## SERVICE BULLETIN

**NUMBER:** 16-112-18R

**SUBJECT:** Ignition Key Sticking / Design Change to CVT Shifter / Selector Lever Components

**For Legacy and Outback:**

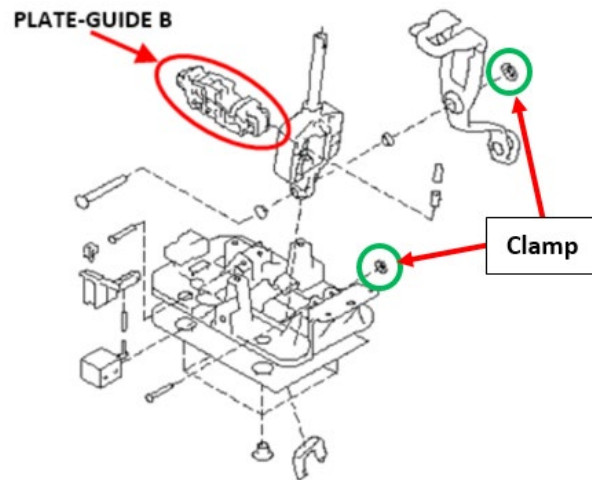
- The term PLATE-GUIDE B refers to the Park-Range switch which is a serviceable part of the select lever assembly on all models listed above **EXCEPT** Legacy and Outback. See the illustrations provided below for more details.
- For **Legacy and Outback**, the shifter assembly (SELECT LEVER COMPLETE) must be replaced if the Park-Range switch is found to be faulty.

- Replace the SELECT LEVER COMPLETE assembly (on Legacy and Outback models) or,
- Replace the Park-Range switch (PLATE-GUIDE B) following the Select Lever disassembly / assembly procedure in the applicable Service Manual.

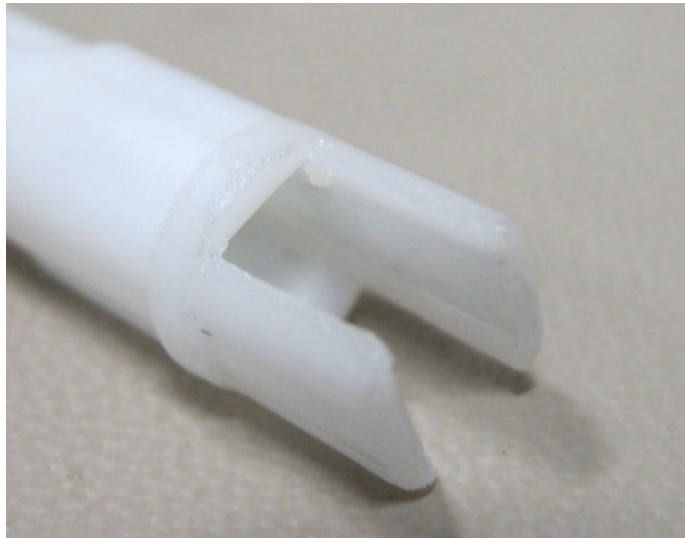
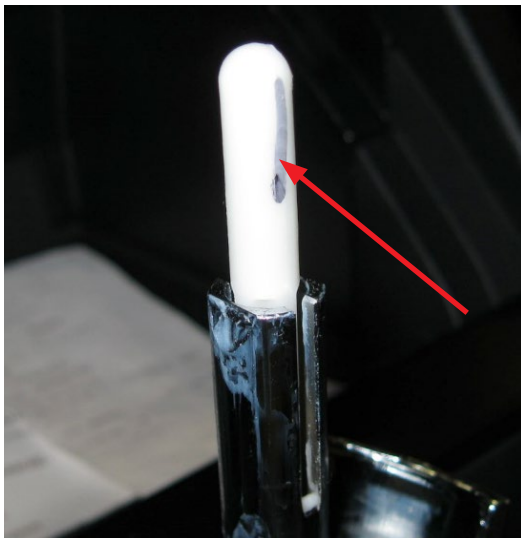
**IMPORTANT TIP:** After removing the shift knob there will be a white plastic rod / plunger protruding from the top of the chrome lever. Use a permanent marker and mark its position as shown in the photo so it can be put back in the same place during reassembly. The bottom end has a notch in it which **must** be in the correct position for proper operation of the mechanism.
